BUILDINGWORK

PCLS Lakewood Library Demolition BID SET – ADDENDUM NUMBER 1

ISSUED: February 15, 2024

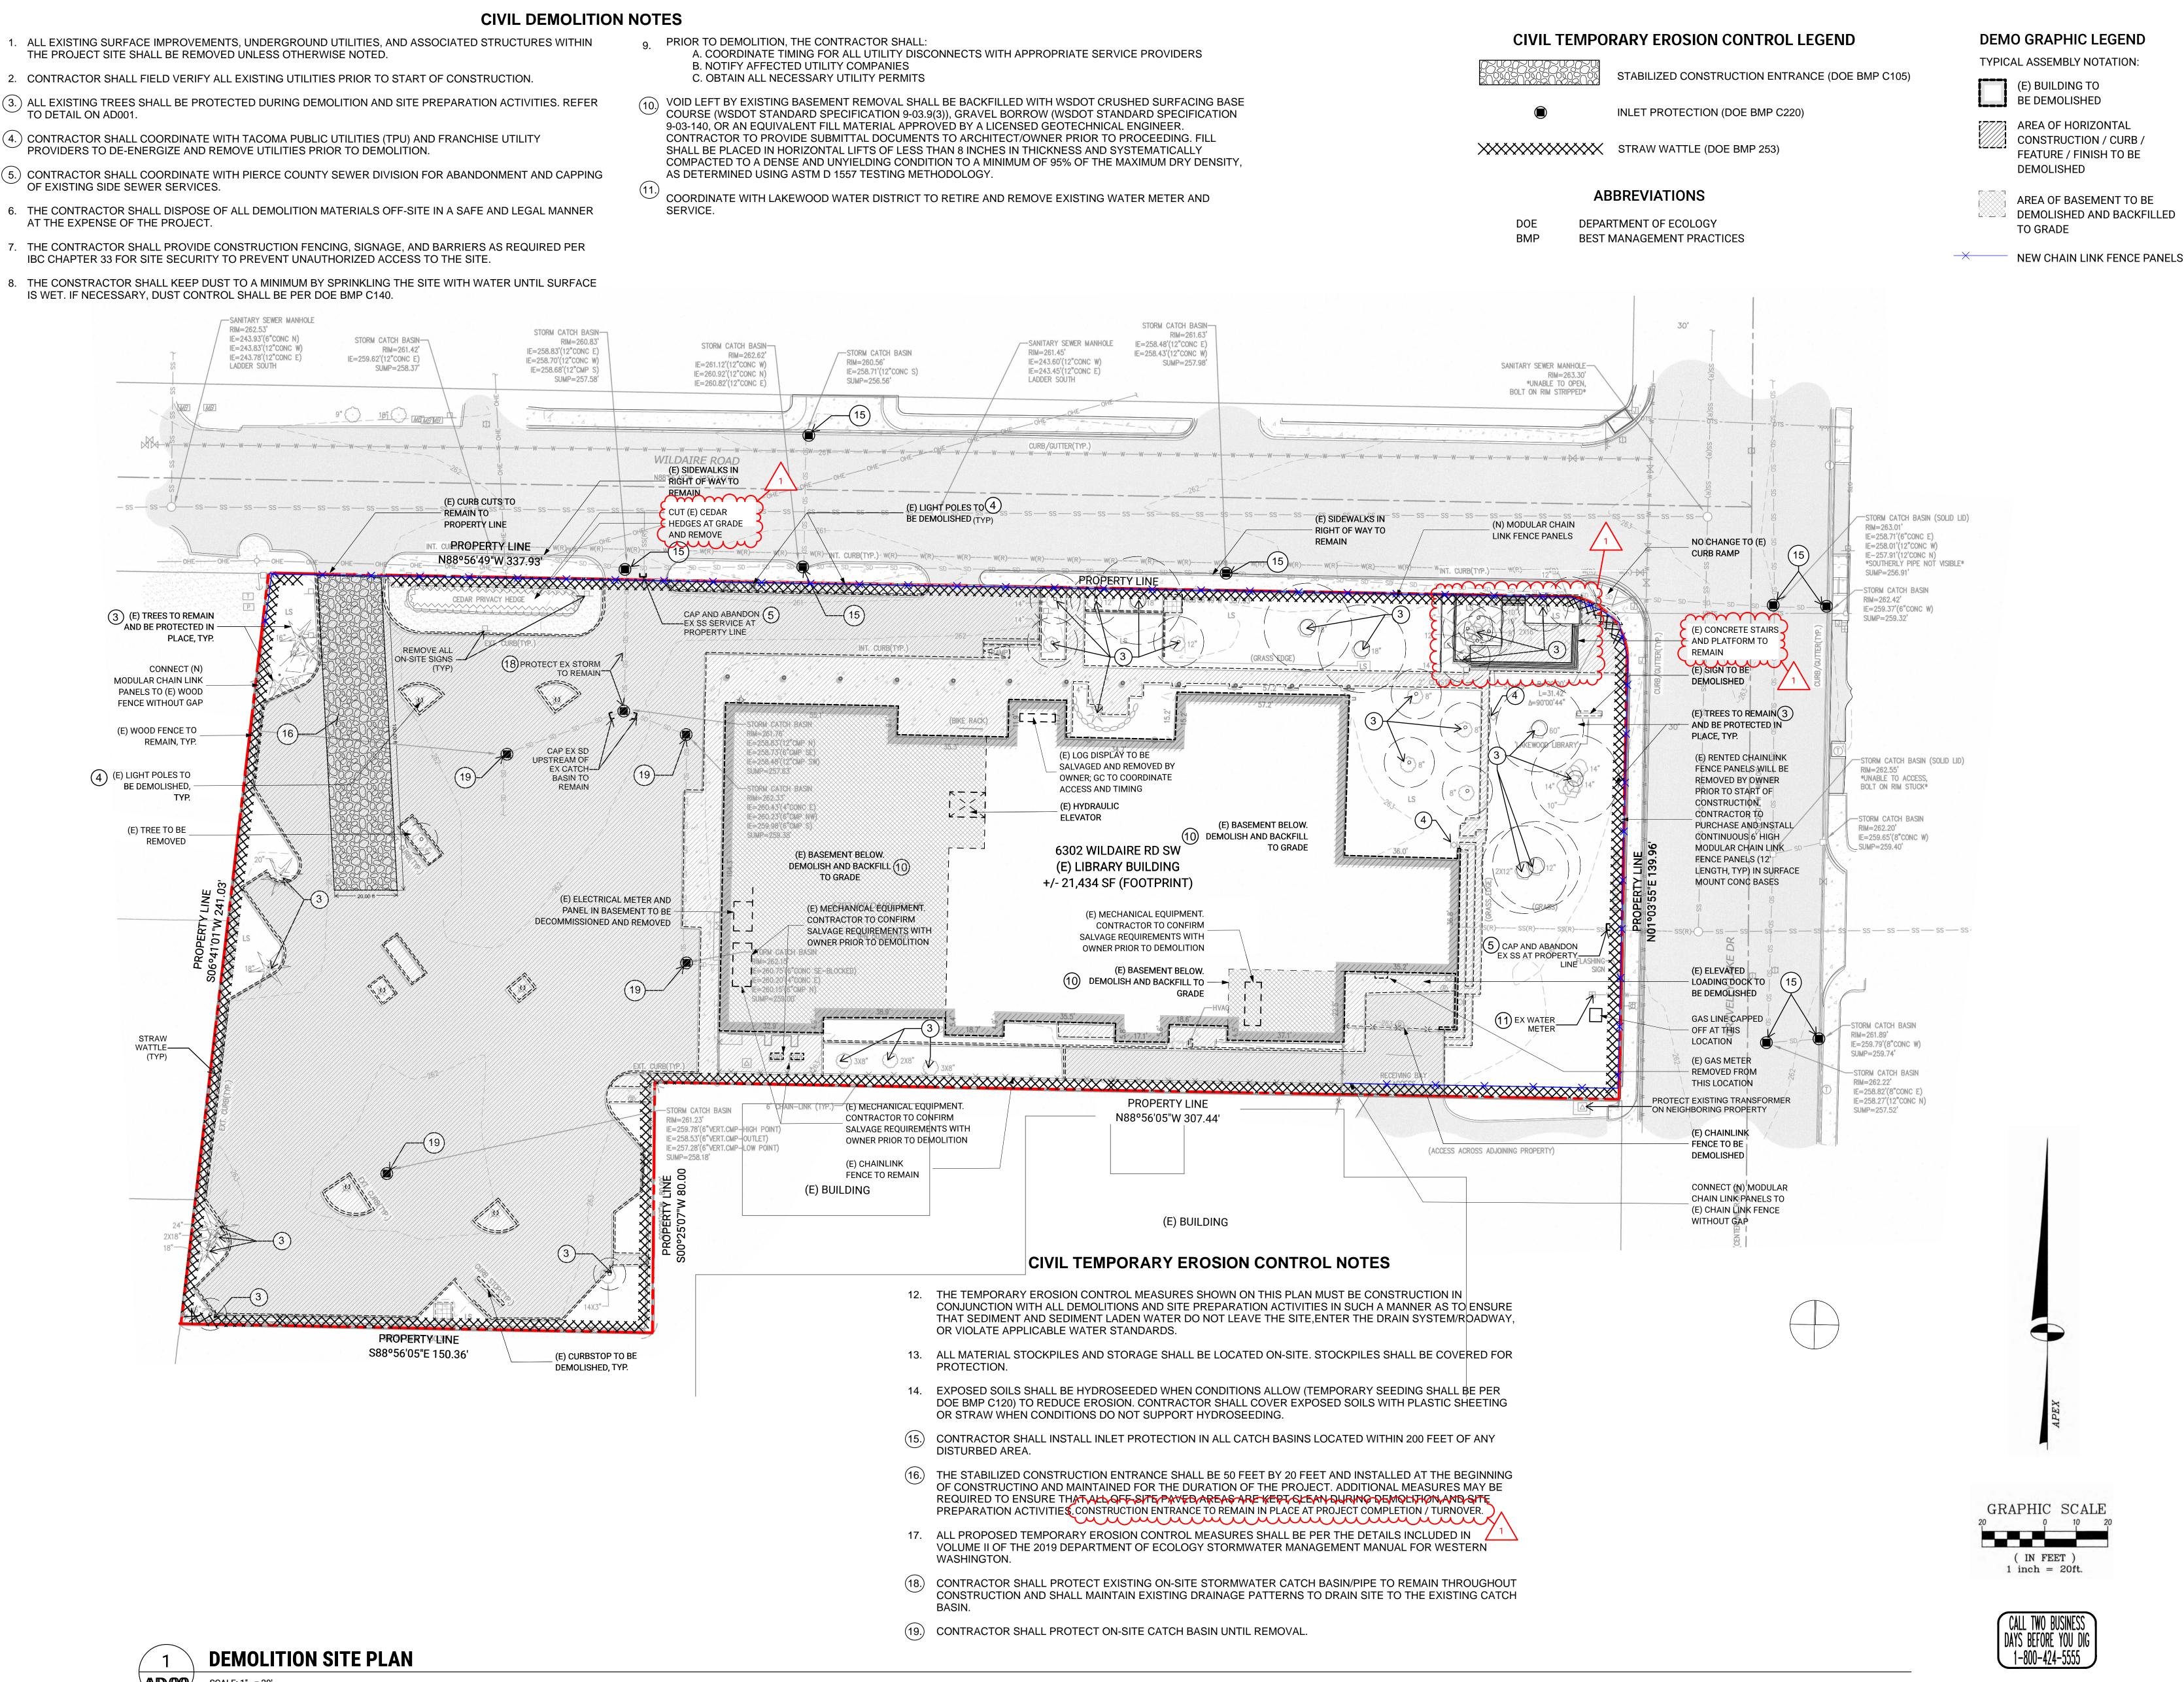
1. Sheet AD 00

Revision: Reduction to extent of site concrete to be demolished and removed in NE corner of site. Existing concrete stairs, platform, and low wall to remain in place as described in plans.

Revision: Existing cedar hedge near new construction entry to be cut to grade and removed. Removal of roots is not required.

- 1. **Question:** Is the construction entrance to remain at the end of the project or be removed? **Answer:** Construction entrance may remain in place at the end of the project. See revised note 16 on AD 00.

- 3. Question: Only one storm basin appears to remain per plans, is that correct? Answer: Correct. See notes 18 and 19 with tagged locations for modifications to existing storm system.
